**Springville City
BARTHOLOMEW WATER TANK
Contract Documents**

ADDENDUM #02

June 07, 2018

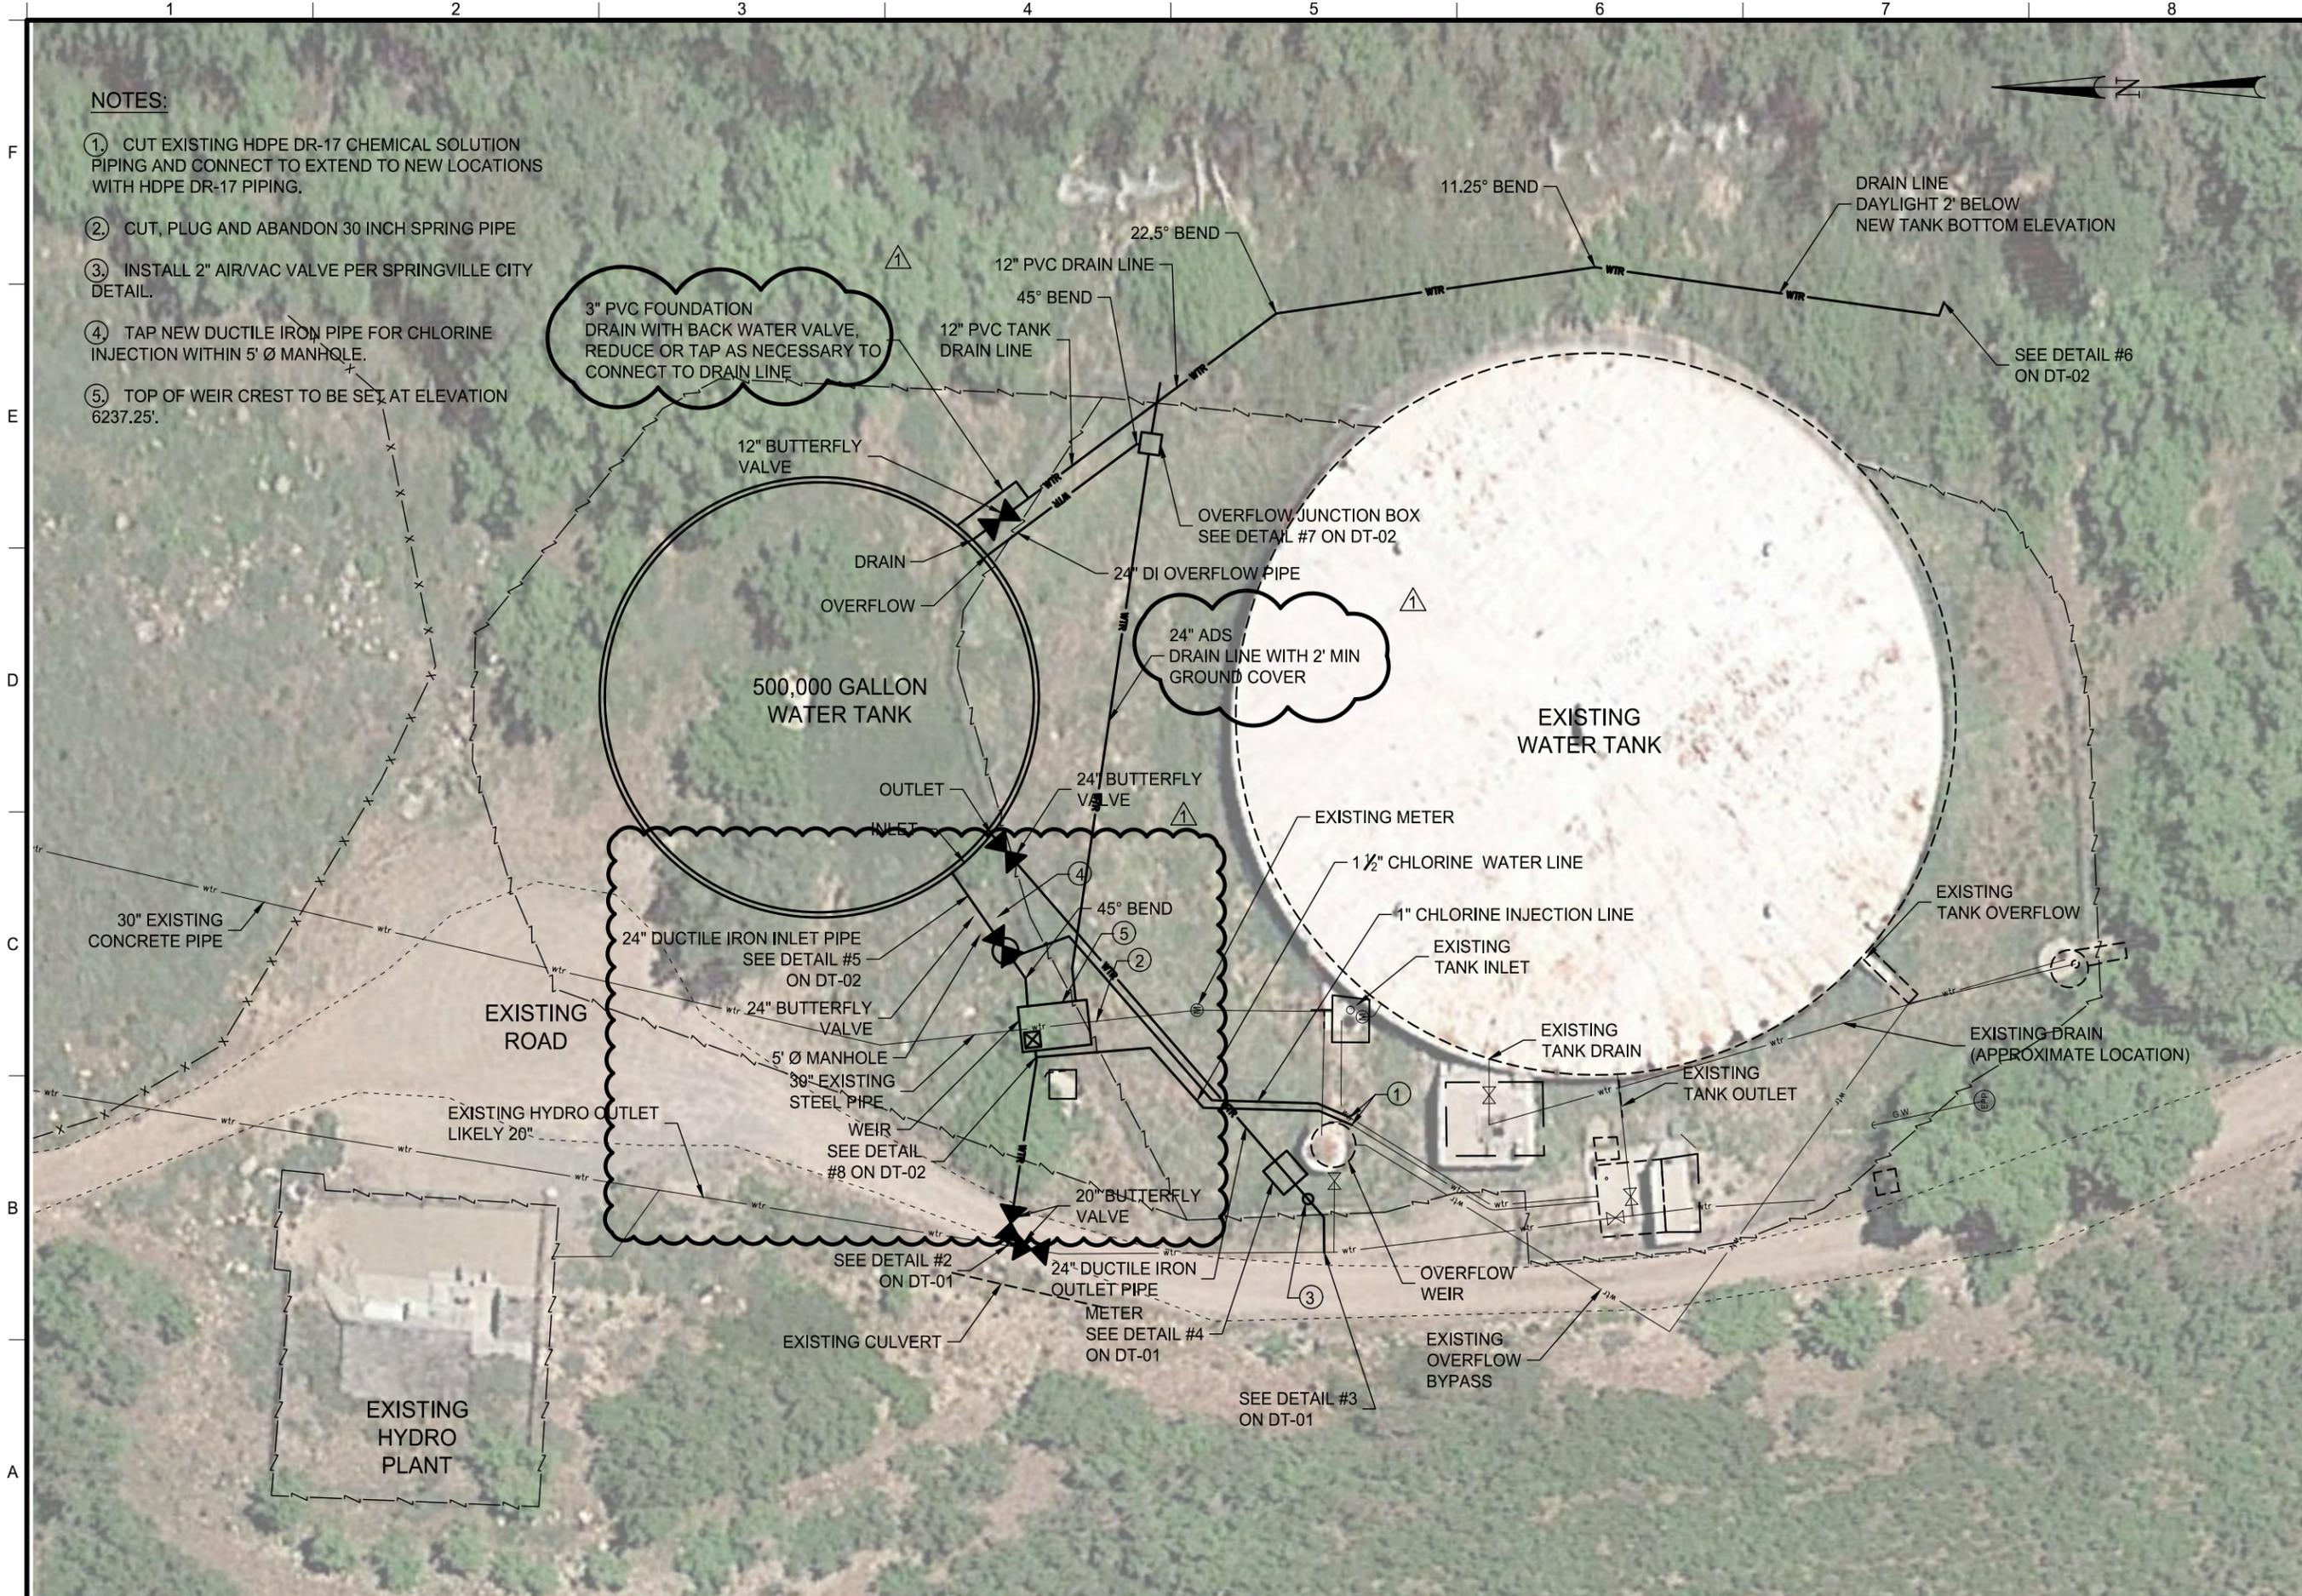
1. Site and Civil Drawings
 - a. Replace drawings C-101, P-101, C-301 and DT-02 with revision 1 drawings. Revision include:
 1. Realignment of existing pipe and relocation of Weir Box, changing Weir Box Drain line to ADS material, adding foundation drain with tie-in to tank drain and revising drain outlet screen call-out.
2. Tank and Weir Structural Drawings

1	FIELD DRAIN PLAN	
3/32" = 1'-0"

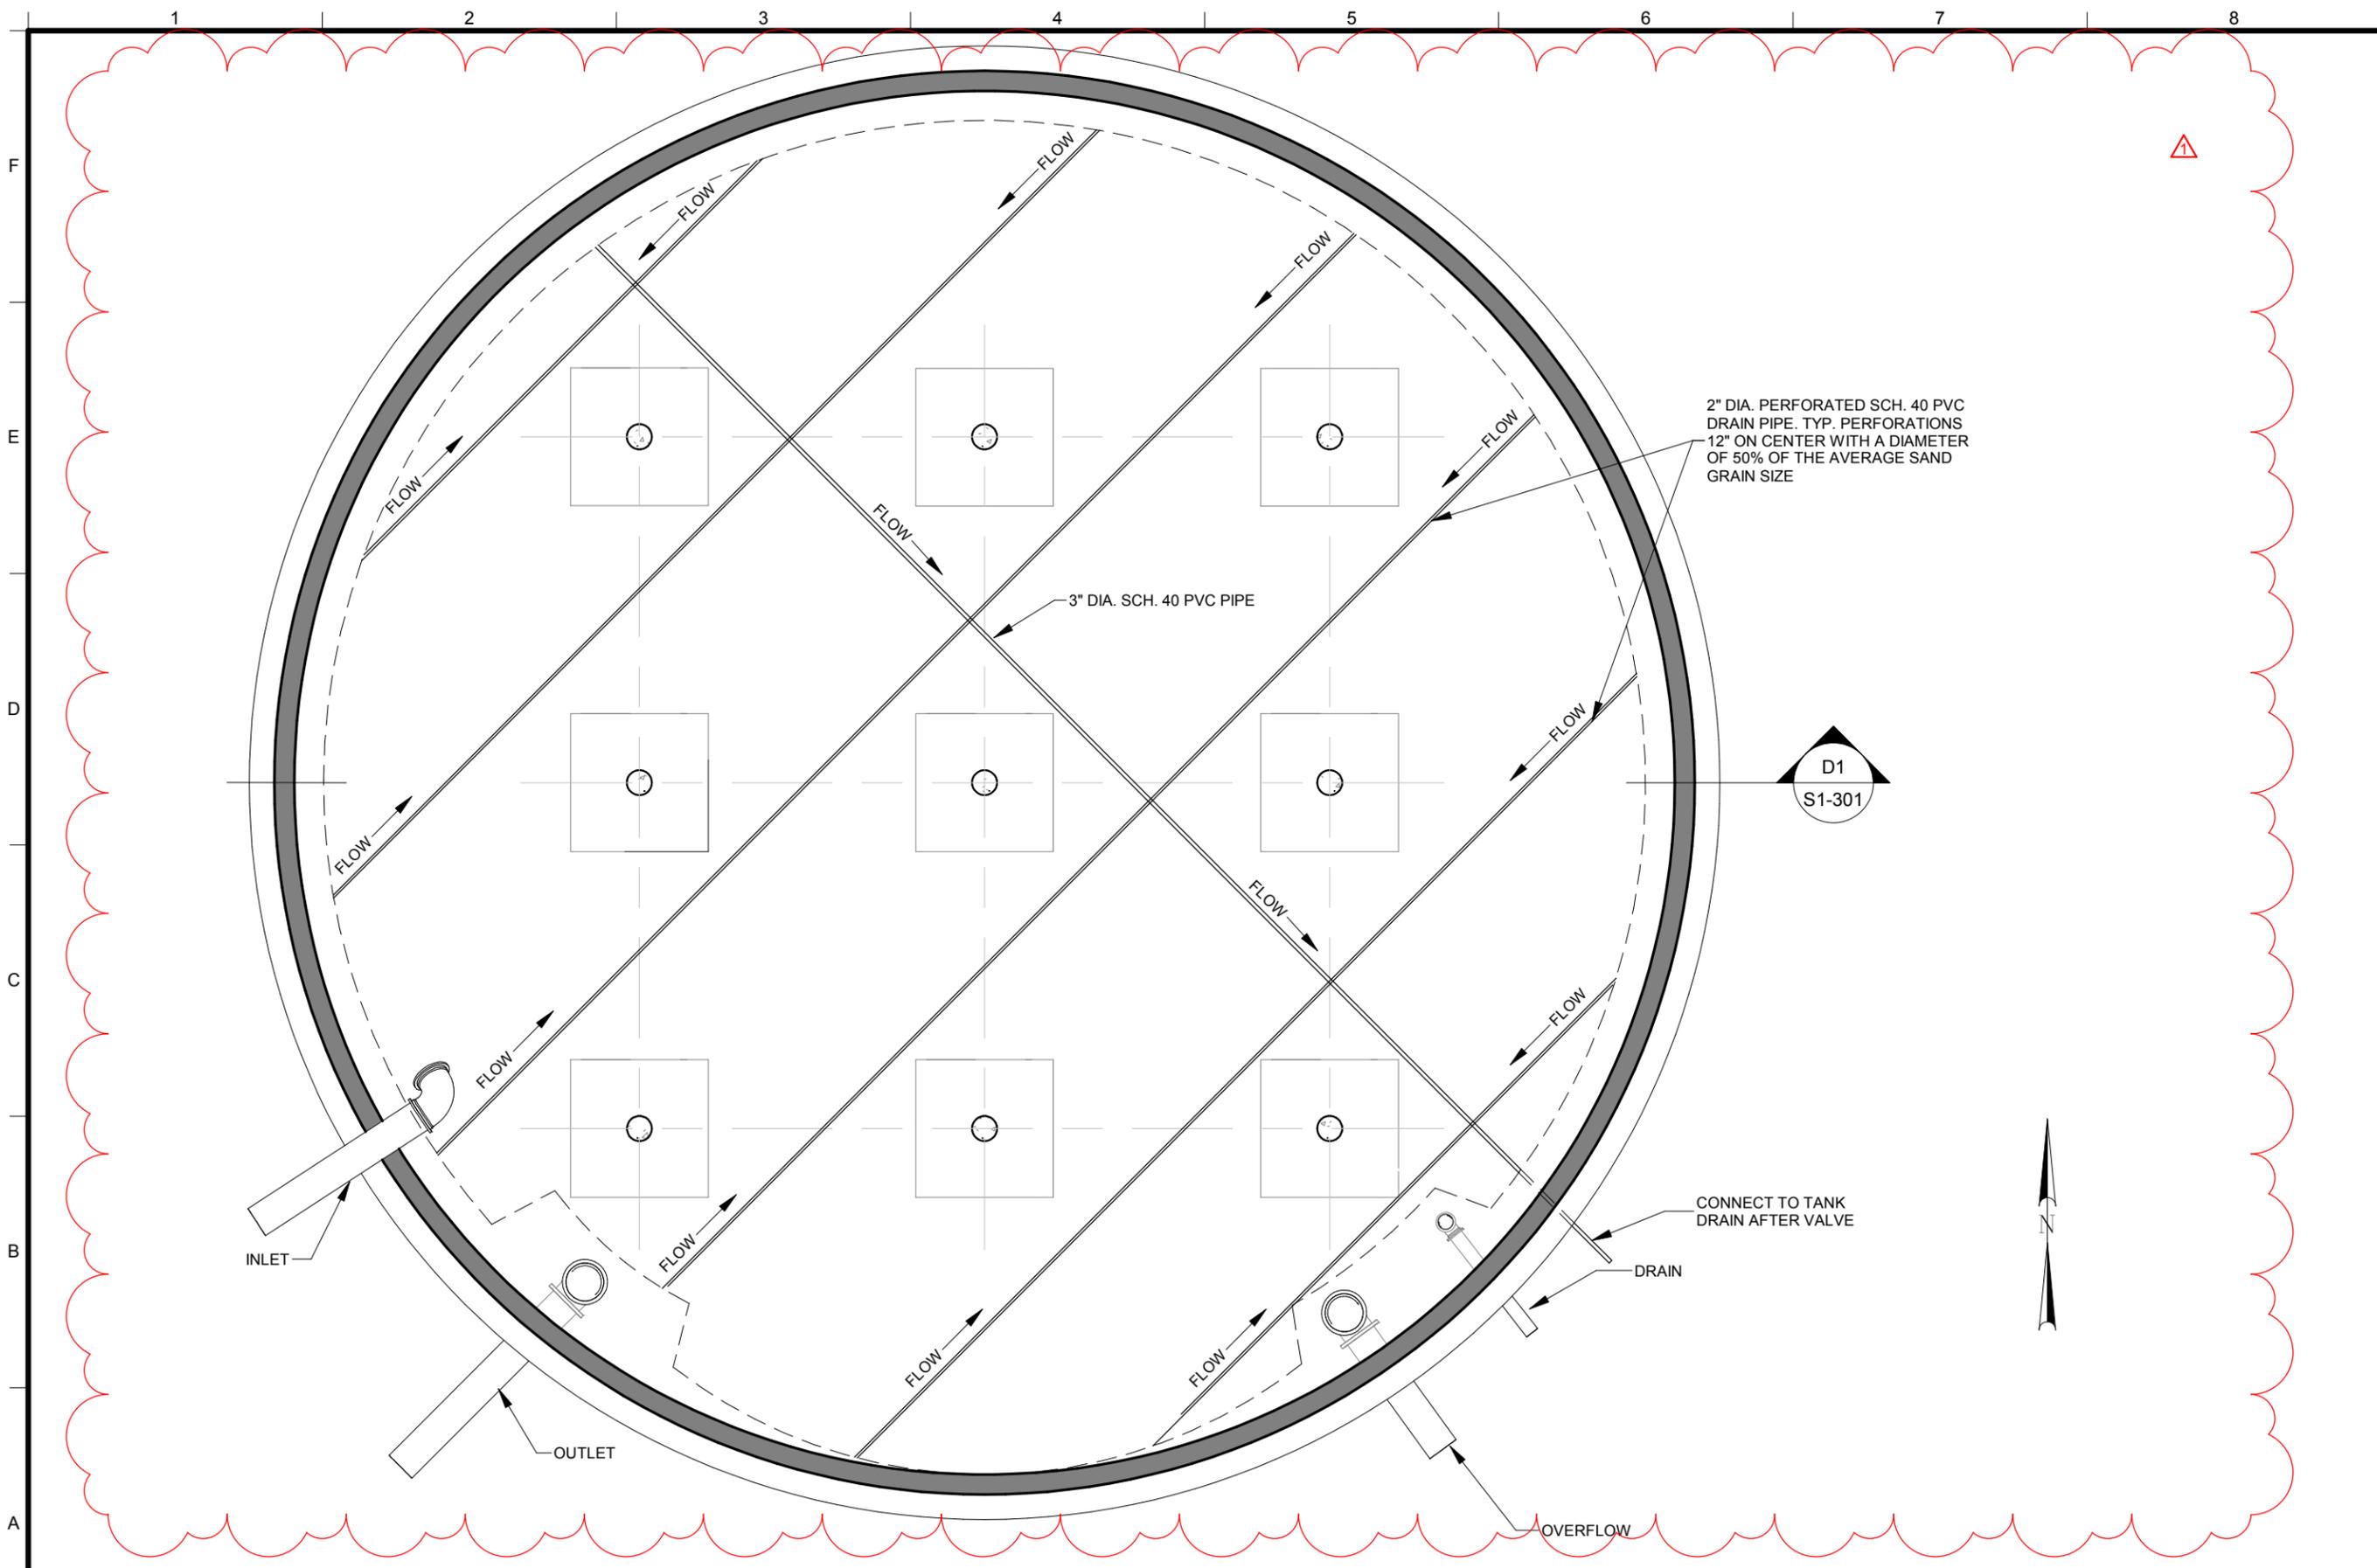
- a. Replace/Add drawing S1-102, S1-103, S1-301, S1-502, S1-601, S2-101, S2-202 and S2-502 with revision 1 drawings. Revisions include:
 - 1. Addition of Tank Foundation Drain Field with cross section, clarity of roof slab thickness, increased curb height for access hatch, revised access hatch type and additional detail on the weir box hatch.
